AUTOMATIC TRANSMISSION SERVICE GROUP

**REVISED EDITION**

Since the introduction of the THM 440-T4 Transaxle in April, 1984, there have been many major engineering design changes. These changes have affected nearly every part used in the THM 440-T4. This Update Handbook will explain each change, the parts affected by the change, and any parts interchangeability problems created by the change.

Figure 73

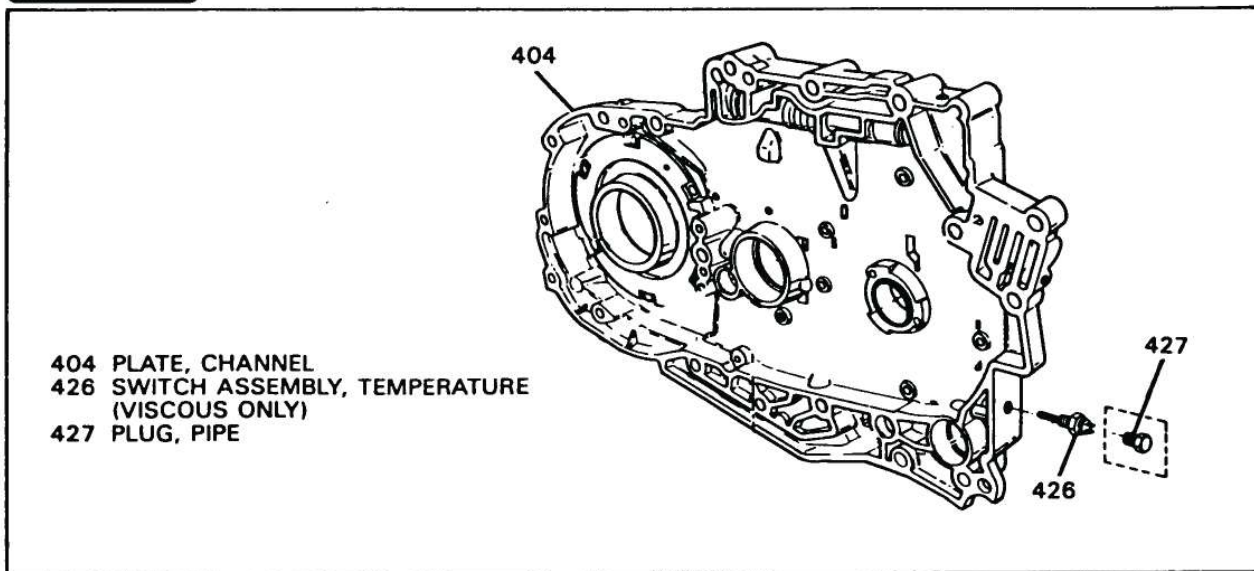
CHANGE: Thermister located in oil pump housing moved into cooler line (See Figures 72 & 74). Temperature switch in channel plate was also eliminated (See Figure 73).

- (1) Thermister - Removed from pump housing (See Figure 72).
- (2) Temperature Switch - Eliminated (See Figure 73).
- (3) Cooler Line - Temperature Sensor added (See Figure 74).
- (4) Case Connector - "E" terminal that normally carried the thermister wire is now empty (See Figure 75).
- (5) Vehicle Wiring Harness.

Figure 76

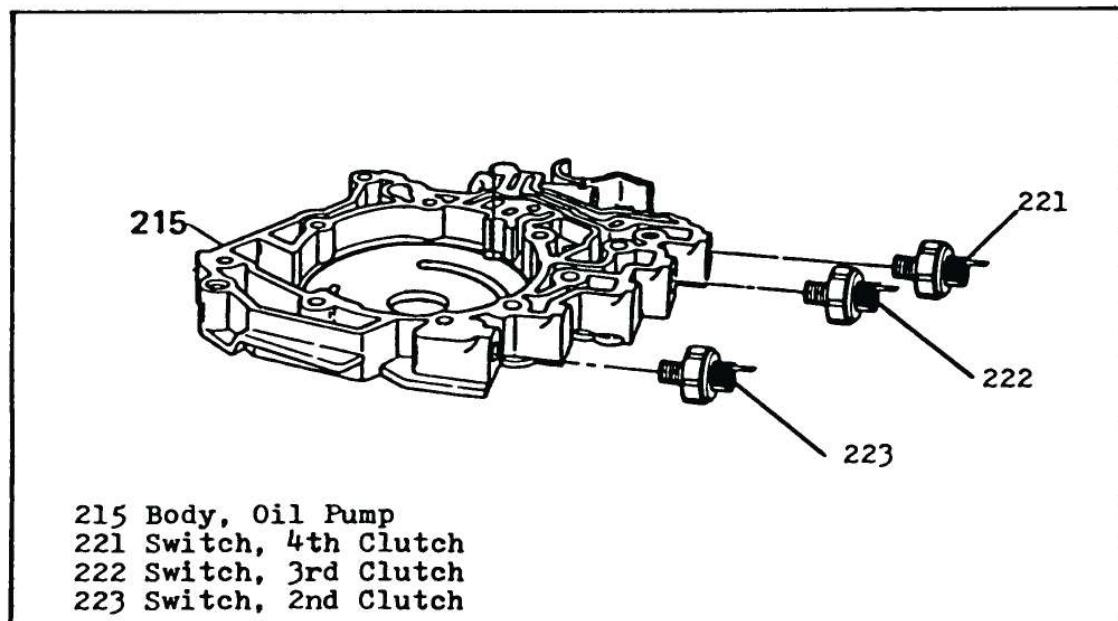
- (1) Pump Body - Drilled and tapped for 2nd clutch switch.
(See Figure 76).
- (2) Valve Body - Extra hole drilled in valve body to carry 2nd clutch oil to pump body.
- (3) Case Connector - Now round black connector (Same as Cadillac), and "E" terminal now carries 2nd clutch signal wire (See Figure 77).
- (4) Transaxle Wiring Harness - Extra wire in harness for 2nd clutch signal to ECM (See Figure 77).
- (5) Vehicle Wiring Harness

Figure 80

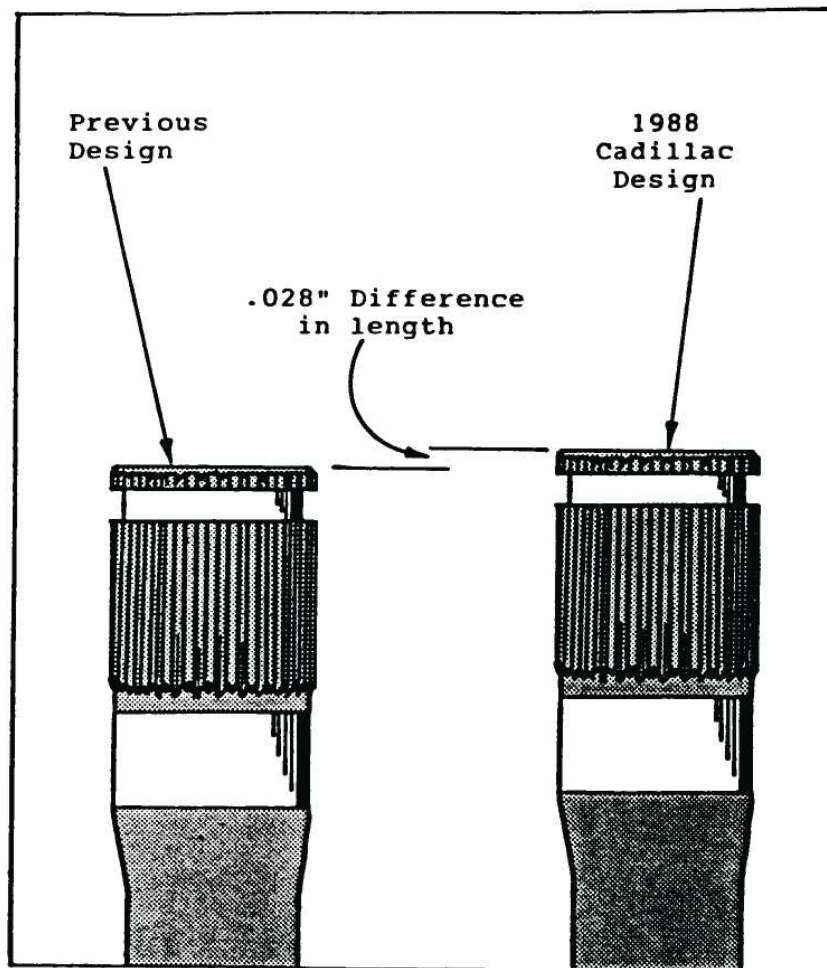
- (1) Differential Side Gears - Revised dimension (Thicker), and they have 16 teeth instead of previous 15.
- (2) Differential Pinion Gears - Revised dimension, and have 10 teeth instead of previous 11.
- (3) Side Gear Thrust Washers - Revised dimension.
- (4) Pinion Gear Thrust Washers - Revised dimension.
- (5) Differential Housing - Revised dimensions (Internal), to accept new side gears and new pinion gears.
- (6) Differential Pinion Shaft - Black in color to identify the new design final drive assembly (See Figure 79). Also is a smaller diameter.
- (7) Output Shaft - Longer (.028"), so that it will extend through the thicker side gears, to get "C" clip installed. The longer output shaft can be identified by green paint on the end of the shaft opposite the "C" clip end (See Figure 80).

Figure 81

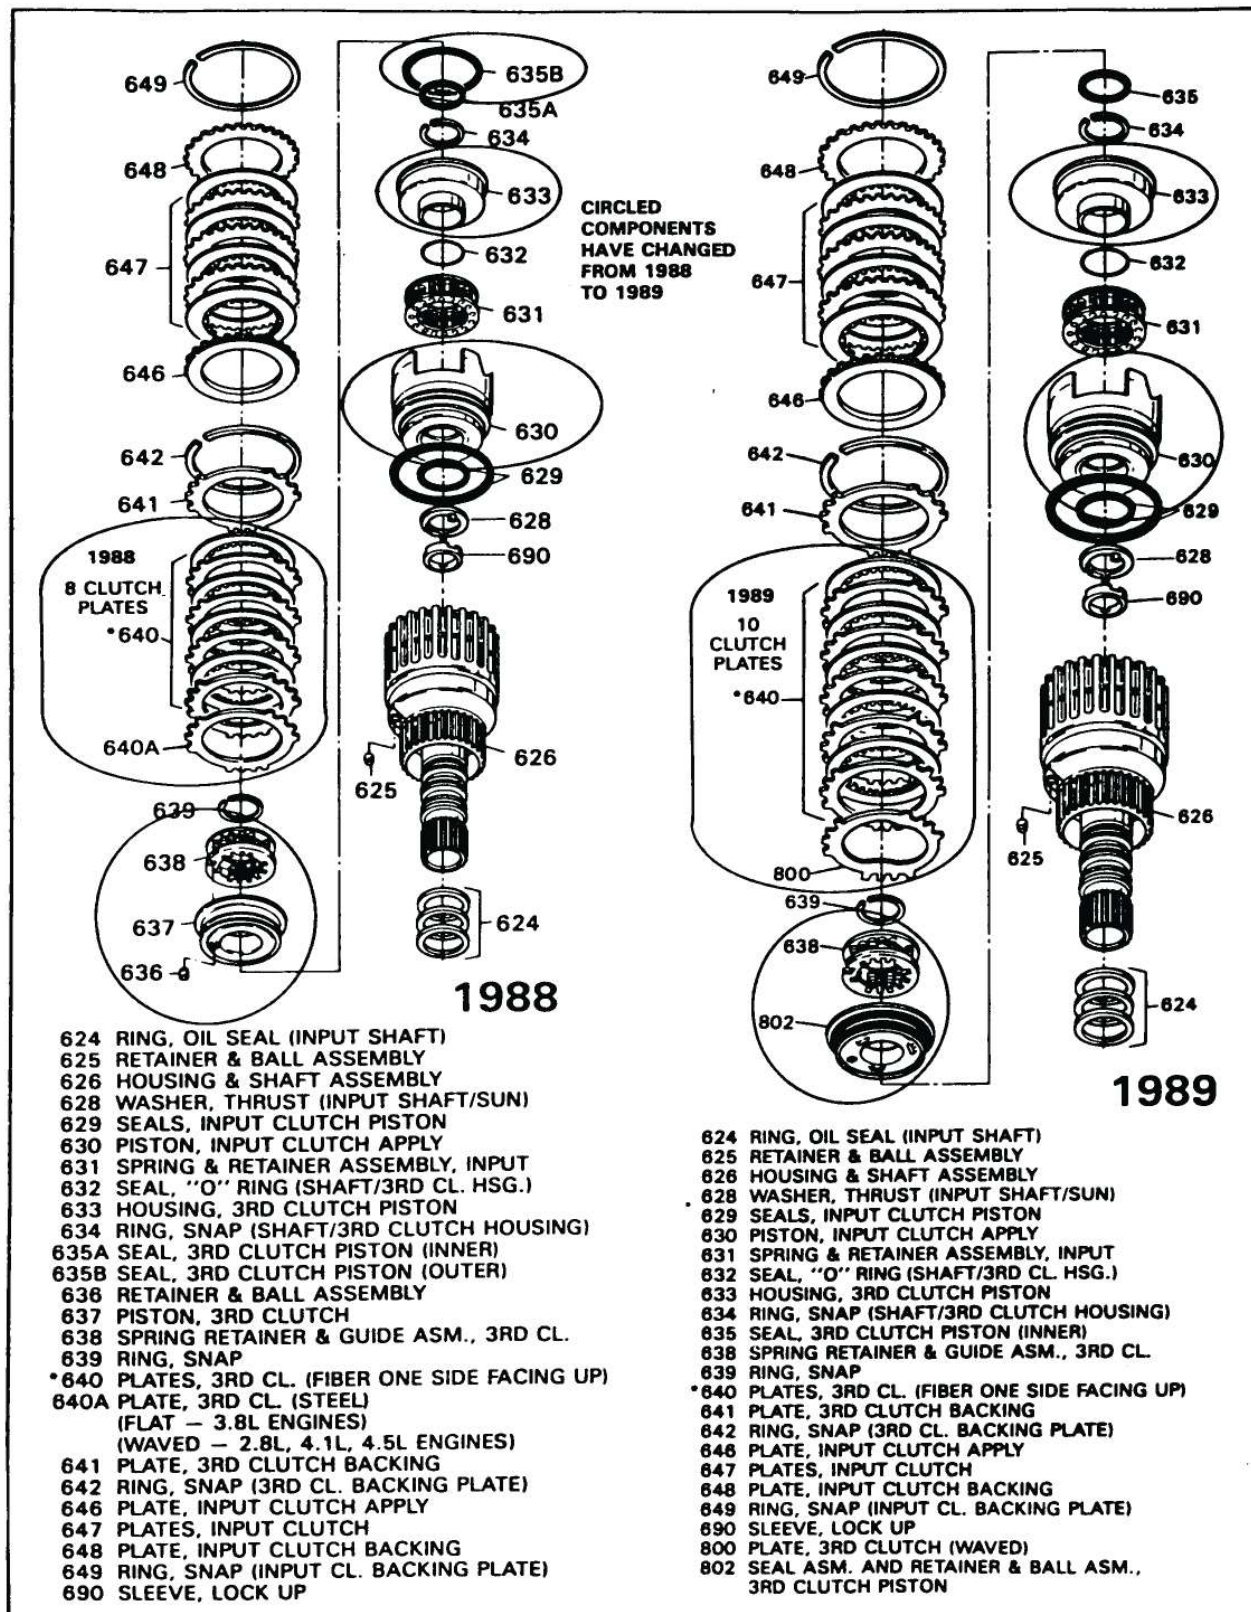
CHANGE: The single sided 3rd clutch plates were "Increased" from the 8 plate clutch pack to a 10 plate clutch pack for all 1989 model THM 440-T4 transaxles (See Figure 81).

Figure 82

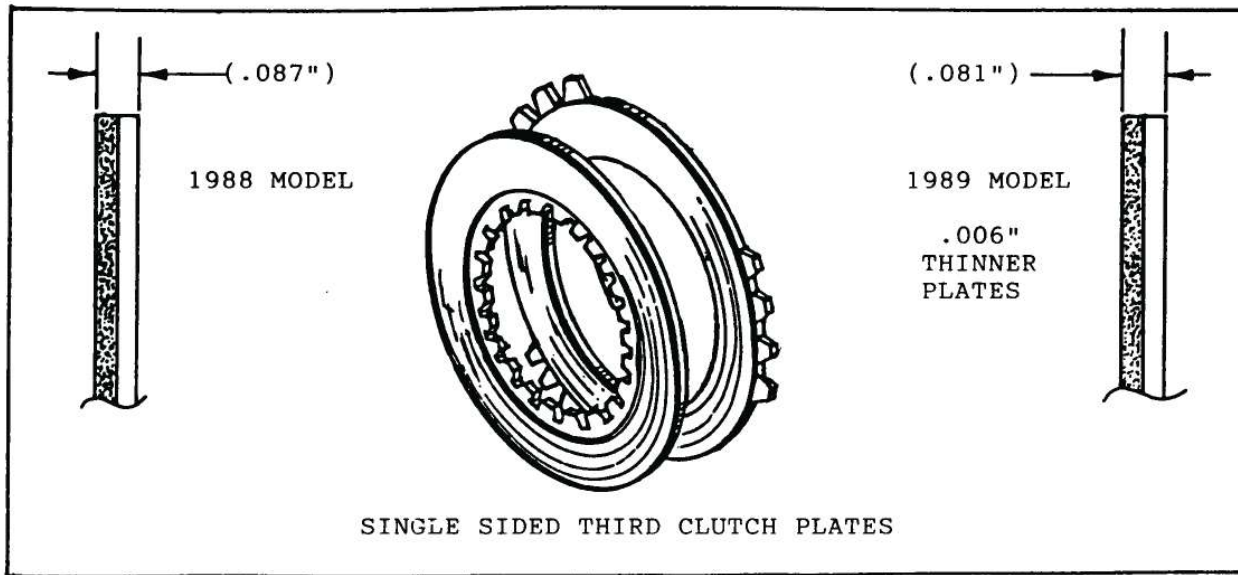
- (1) Single Sided 3rd Clutch Plates - Both inside and outside spline plates are .006" thinner for 89, to make room for the two additional plates (See Figure 82).

Figure 85

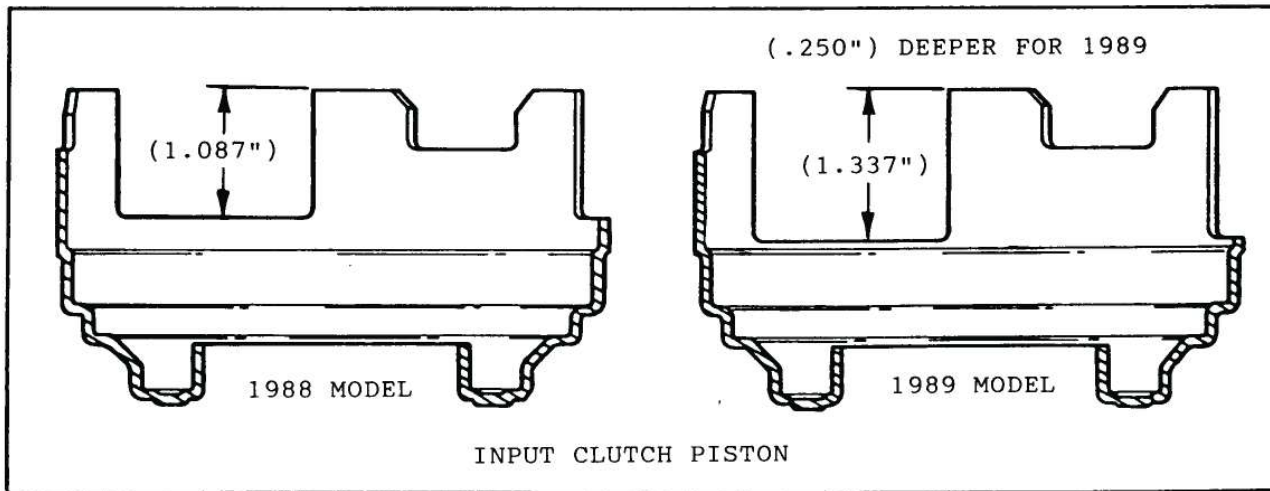
- (4) Input Clutch Piston - The cutouts in the piston for the 3rd clutch plates are .250" deeper to accomodate the additional two clutch plates in the 3rd clutch pack (See Figure 85).

Figure 86

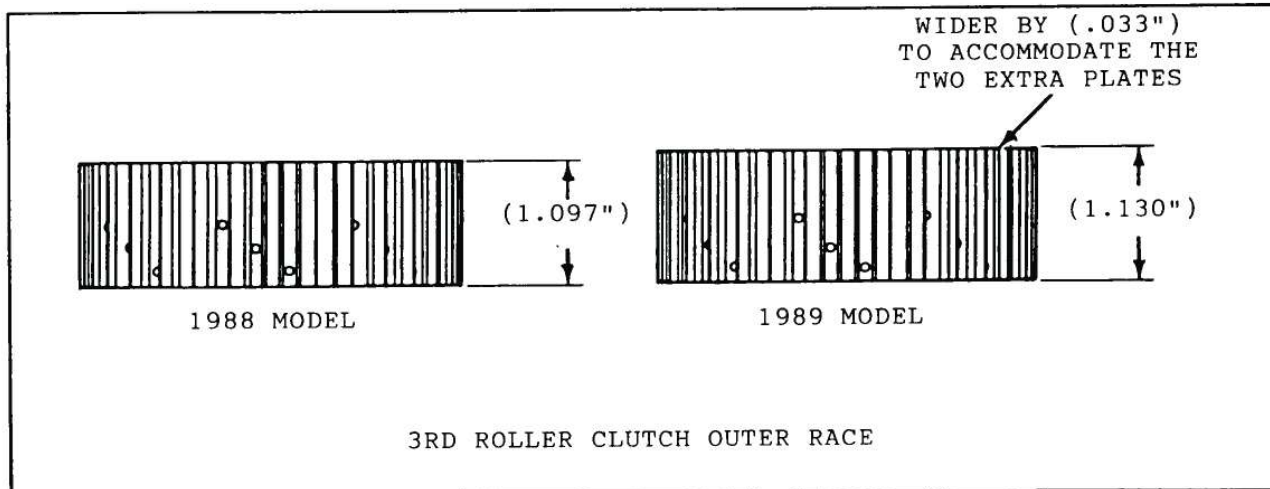
- (5) 3rd Roller Clutch Outer Race - The outer race was made wider by .033" to accomodate the two extra plates. The rollers have not changed in width (See Figure 86).

Figure 87

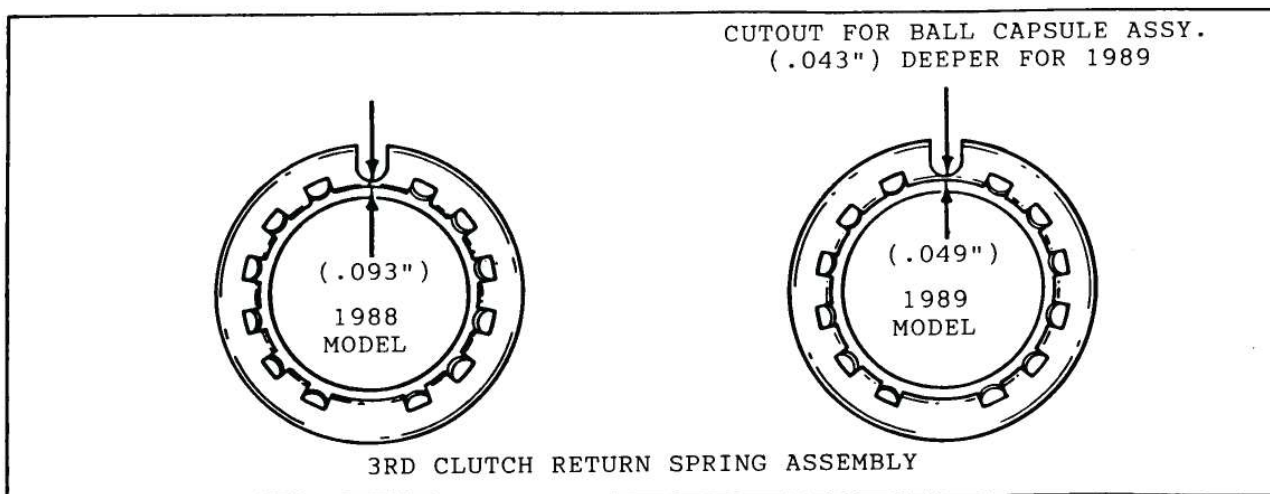
- (6) 3rd Clutch Return Spring Assembly - The cutout in the retainer is .045" deeper to accomodate the relocated ball capsule in the new (Smaller Diameter) 3rd clutch piston and seal Assy. (See Figure 87).

Figure 88
89

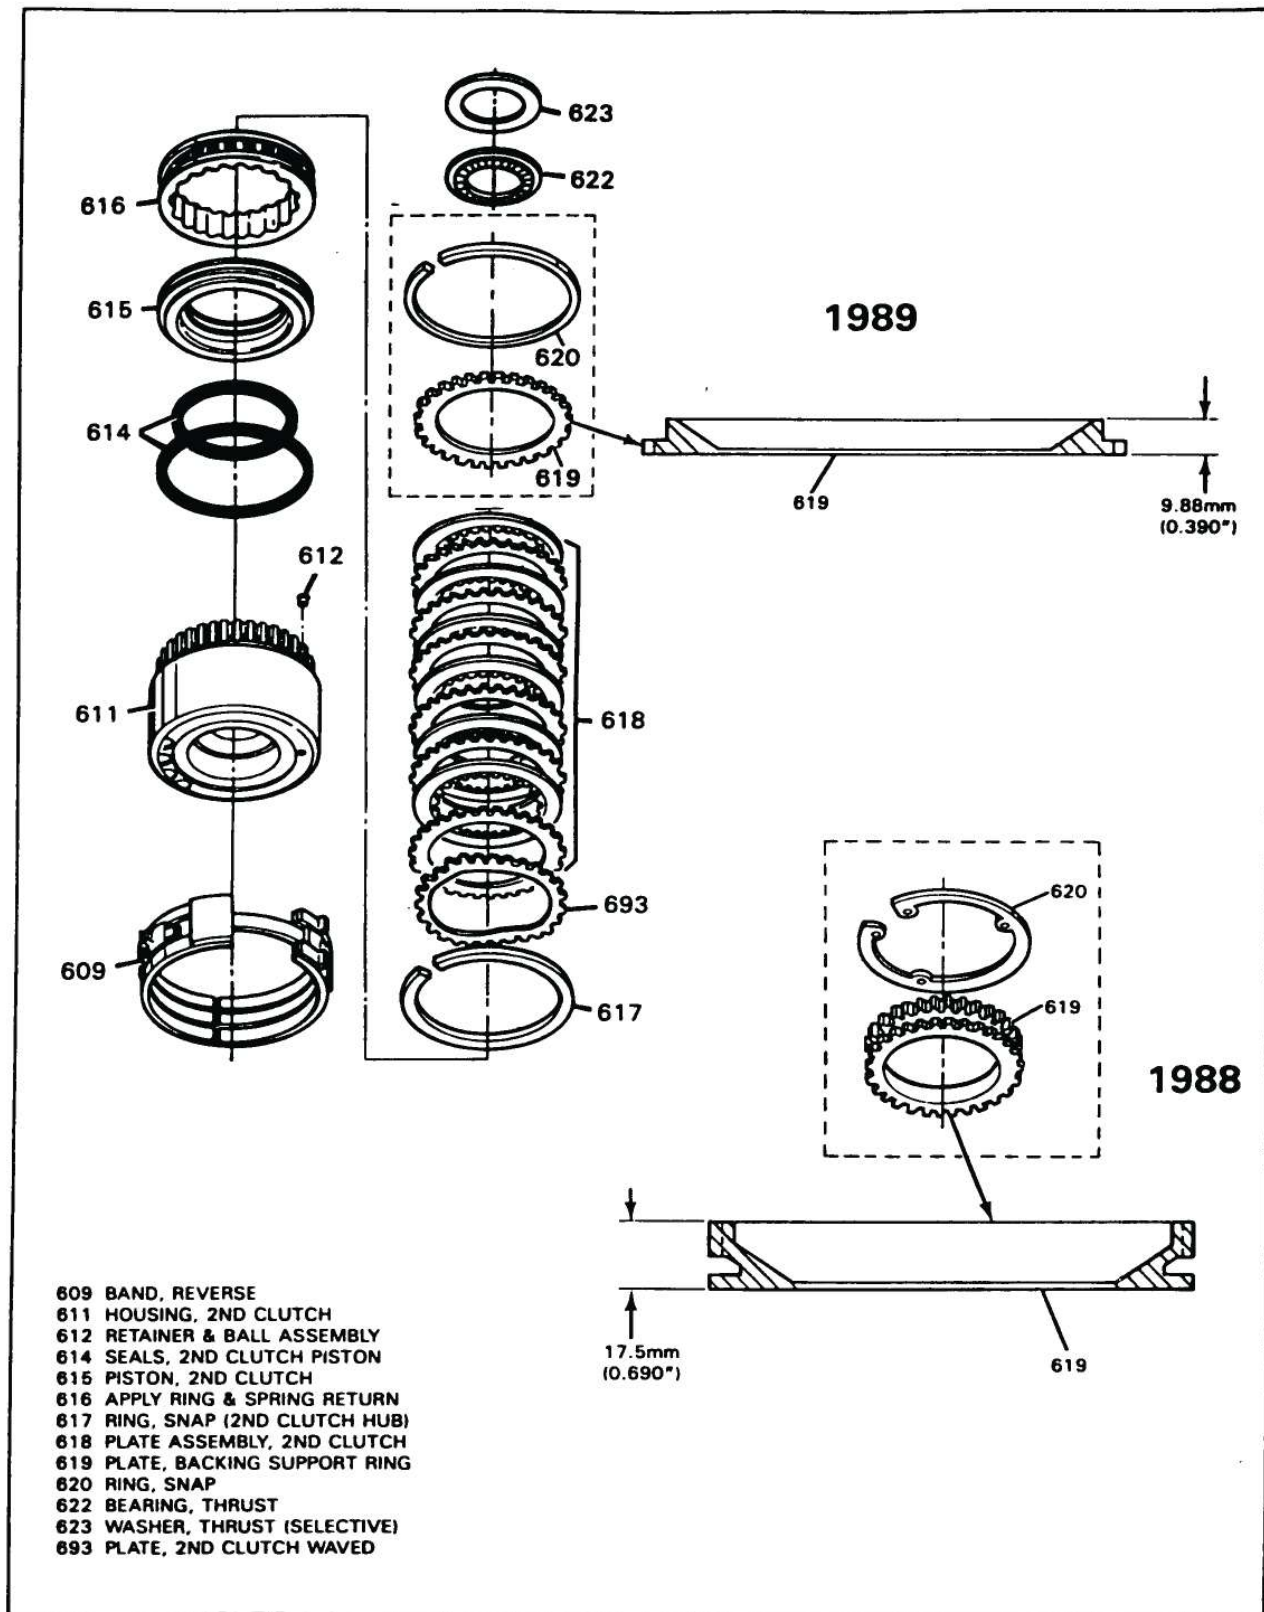
CHANGE: 2nd Clutch Backing Plate was redesigned (See Figure 88).

- (1) 2nd Clutch Backing Plate - "Windows" in backing plate are eliminated which makes the backing plate less prone to warpage. Also notice (See Figure 88) that the support ring has been eliminated from the backing plate and is no longer used, because "Engine Torque Management" was added as an ECM function. This was one of the reasons for the addition of the 2nd clutch switch in 1988.
- (2) 2nd Clutch Backing Plate Snap Ring - The new snap ring is only half as wide as the previous models and must be used with the third design backing plate.
